SERVICE KIT 753-0582

SUBJECT: HEAT SHIELD
MODEL 143W834H401

**PROBLEM: POTENTIAL FUEL LEAKAGE DUE TO HEAT SHIELD INTERFERENCE
WITH CARBURETOR FLOAT BOWL.**

SOLUTION: INSTALL KIT NUMBER 753-0582

FIGURE 1

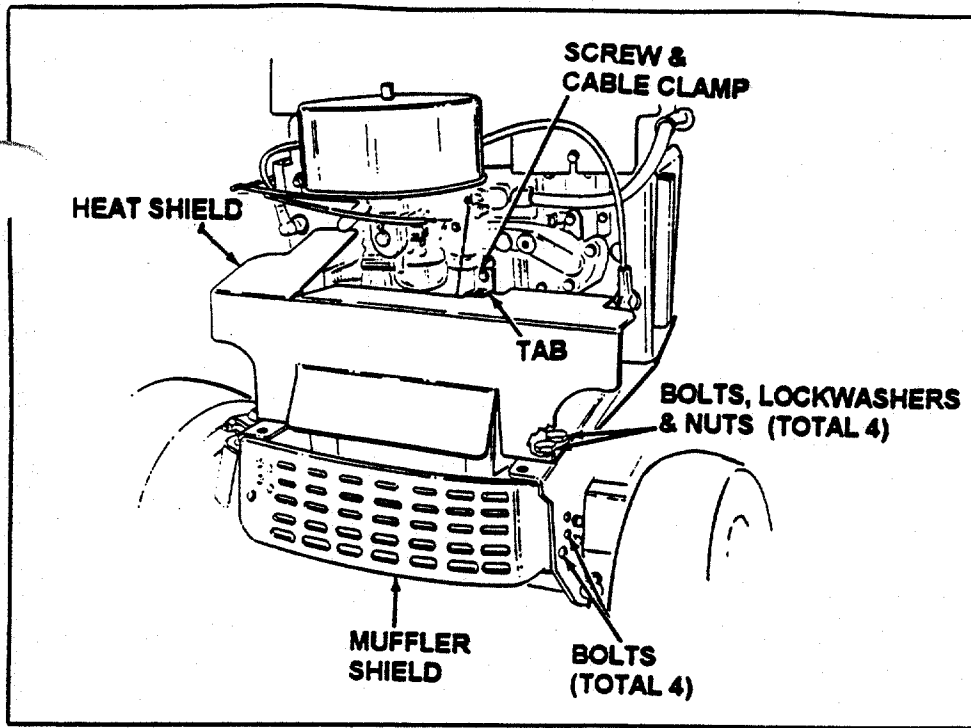
5. USING A 1/4" SOCKET, REMOVE THE SCREW AND UNUSED CABLE CLAMP ON THE ENGINE. DISCARD THE CABLE CLAMP BUT RETAIN THE SCREW. SEE FIGURE 1.
 6. IF THE OLD HEAT SHIELD HAS BEEN RUBBING AGAINST THE CARBURETOR FLOAT BOWL YOU MUST REPLACE THE CARBURETOR FLOAT BOWL, FLOAT GASKET AND BOWL SCREW GASKET. SEE FIGURE 3

9. IMPORTANT
USING THE SMALL SCREW THAT WAS ATTACHED TO THE ENGINE THAT YOU REMOVED IN STEP 5, ATTACH THE TAB ON THE NEW HEAT SHIELD TO THE ENGINE. SEE FIGURE 1.

10. INSTALL THE MUFFLER SHIELD USING FOUR BOLTS. SEE FIGURE 1.
 11. INSTALL THE HOOD AND GRILL.
 12. REATTACH THE WIRE HARNISS TO THE HEADLAMPS.
 13. PLACE THE GREEN (X) PROVIDED IN THIS SERVICE KIT NEXT TO THE MODEL PLATE ON THE TRACTOR TO IDENTIFY THAT THIS TRACTOR HAS BEEN REPAIRED.

FIGURE 2

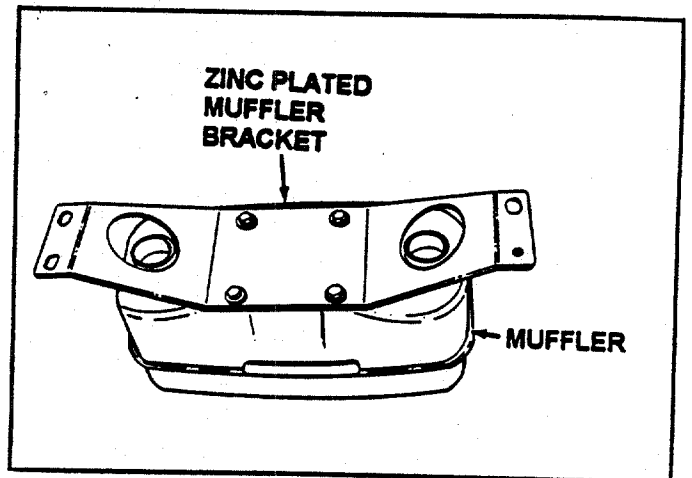
- 1. REMOVE THE HOOD, GRILL AND MUFFLER SHIELD.**
 - A. DISCONNECT THE WIRE HARNESS TO THE HEADLAMPS.**
 - B. REMOVE THE FOUR BOLTS AND NUTS HOLDING THE SIDE PANELS TO THE DASHBOARD PEDESTAL.**
 - C. REMOVE THE FOUR BOLTS HOLDING THE MUFFLER SHIELD TO THE TRACTOR FRAME. SEE FIGURE 1**
 - D. REMOVE THE FOUR BOLTS, LOCKWASHERS AND NUTS HOLDING THE GRILL TO THE FRAME OF THE TRACTOR.**
- 2. REMOVE THE FOUR BOLTS AND NUTS HOLDING THE HEAT SHIELD AND MUFFLER BRACKET TO THE TRACTOR FRAME. SEE FIGURE 1.**
- 3. REMOVE THE HEAT SHIELD AND MUFFLER ASSEMBLY.**
- 4. REPLACE THE PAINTED MUFFLER BRACKET. SEE FIGURE 2**

NOTE: THE MUFFLER BRACKET IS NOT SYMMETRICAL. USE THE OLD PAINTED MUFFLER BRACKET TO ORIENT THE NEW ZINC PLATED MUFFLER BRACKET.
